Access Compliance Report Public Rights-of-Way (Curb Ramps)

Main Street: ANTONIO_PKWY Cross Street: O_NEILL_DR Location: SW

ADA ID: RPRK211116125149 Ramp Type: Type 1 - Perpendicular Diagonal Initial Pass/Fail: Fail Overall Compliance: No Severity Score: 2

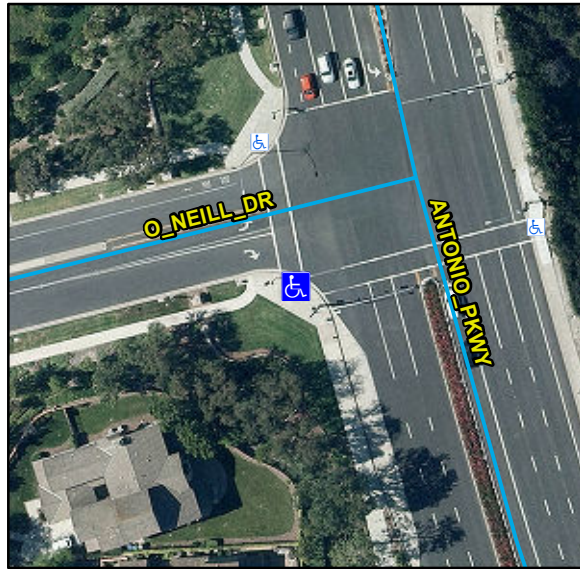
R204.3, R304.5.3, STD 1115

Remove & Replace Curb Ramp With Two New Directional Ramps or Equivalent.
